RFI #027: Civil - Drainage Basin Details

RFI #027: Civil - Drainage Basin RFI

CONSTRUCTION DOCUMENTS
HCA LEE'S SUMMIT
MEDICAL CENTER
2000 SE SHENANDOAH DRIVE
LEE'S SUMMIT, MO, 64063
JACKSON COUNTY

2 **RIP-RAP OUTLET PROTECTION**
NOT TO SCALE

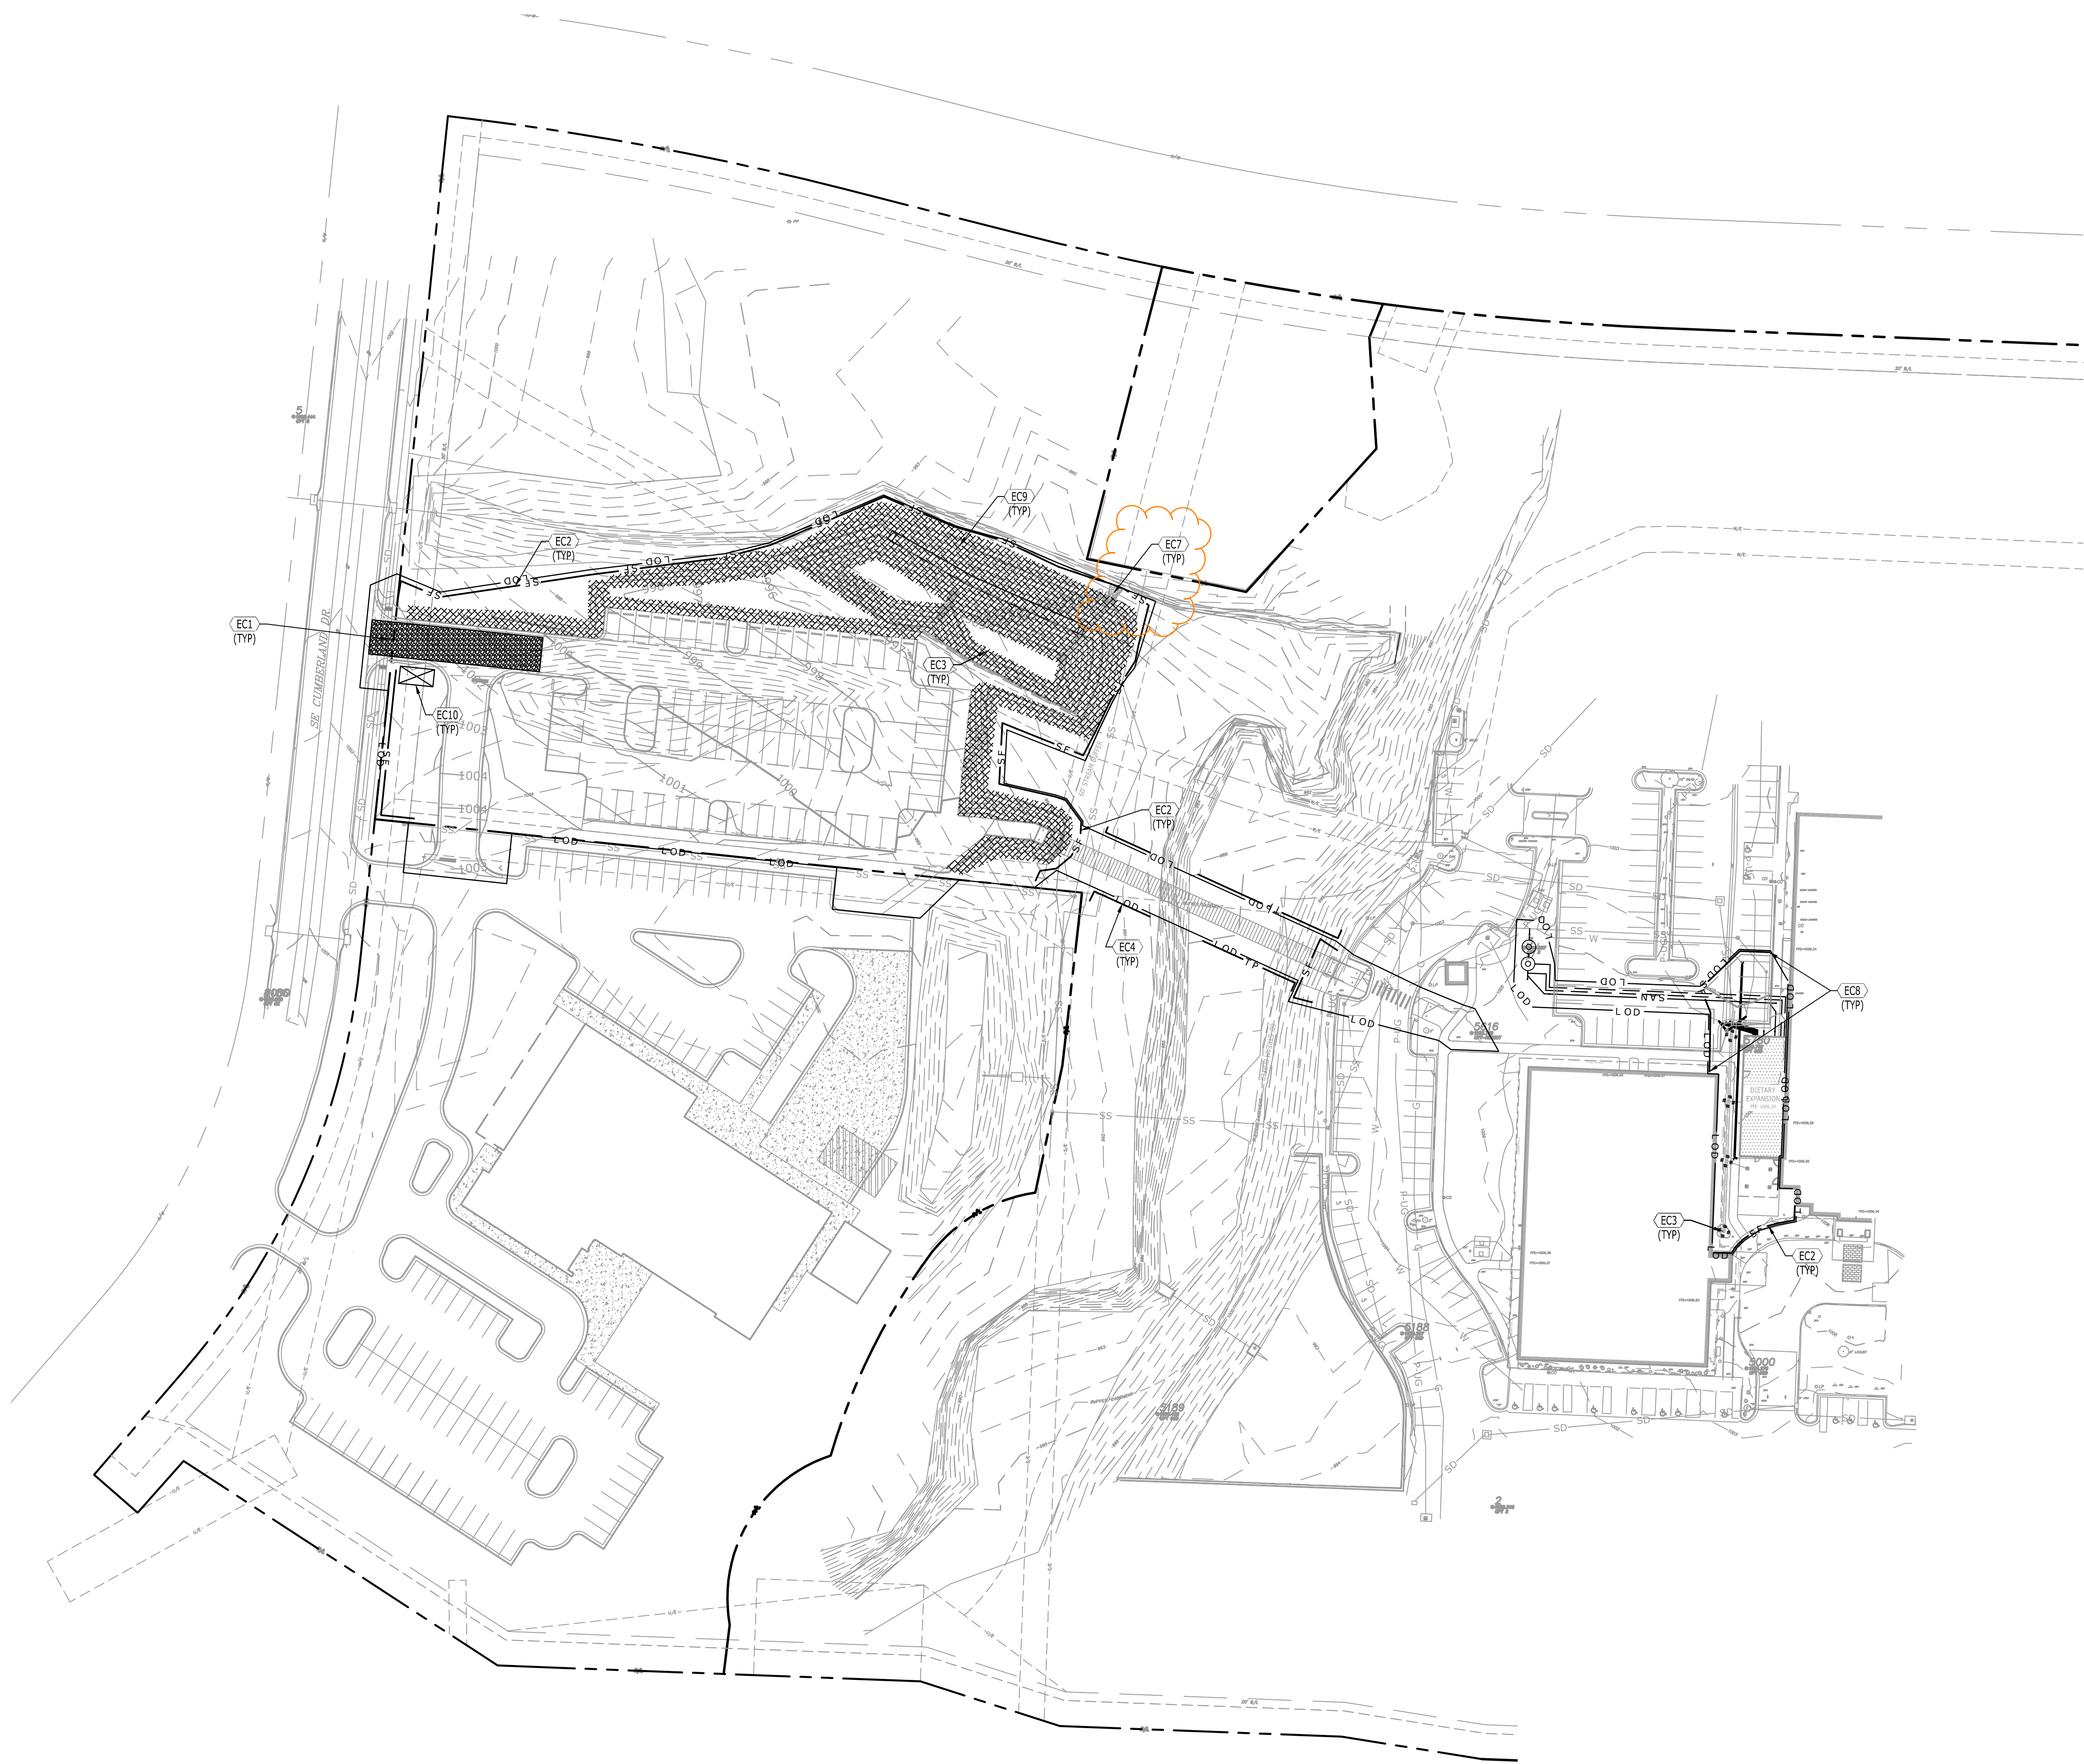
Question	Question from Max Franklin Nabholz Construction Corporation on Monday, Jul 7, 2025 at 08:53 AM CDT Please reference the attached in regard to the following: Q1. DESIGN TEAM TO PROVIDE MISSOURI DOT REFERENCE, CURRENTLY TENNESSEE DOT STANDARDS PROVIDED. Q2. RIP-RAP CALLED OUT TO BE A MINIMUM DEPTH OF 1.5', HOWEVER, SECTION DETAIL SHOWS A DEPTH OF 8". DESIGN TEAM TO CLARIFY RIP-RAP DEPTH. Q3. CODE #5 IS REFERENCED WITHIN THE SECTION, HOWEVER, THERE IS NO CORRESPONDING KEYNOTE WITHIN THE LEGEND LABELED #5. DESIGN TEAM TO CLARIFY WHAT DETAIL #5 IS. Q4: DESIGN TEAM TO PROVIDE MORE DETAIL. Attachments DRAINAGE_BASIN_RFI_07.01.2025.pdf
-----------------	--

Q3. CODE #5 IS REFERENCED WITHIN THE SECTION, HOWEVER, THERE IS NO CORRESPONDING KEYNOTE WITHIN THE LEGEND LABELED #5. DESIGN TEAM TO CLARIFY WHAT DETAIL #5 IS. - NAB-MF-07.01.2025

Q2 - THE DEPTH DESCREPANCY WAS ELIMINATED, USE 1.5' DEPTH (KEYNOTE 1 DESCRIPTION)

Q3 - KEYNOTE 5 IS COMPACTED SUBGRADE.

EASE REFER TO CURRENT DETAIL (FROM PLANS DATED 2/6/25.
 - APWA STANDARDS ARE NOW REFERENCED.
 - THE DEPTH DISCREPANCY WAS ELIMINATED, USE 1.5' DEPTH (KEYNOTE 1 DESCRIPTION)
 - KEYNOTE 5 IS COMPACTED SUBGRADE
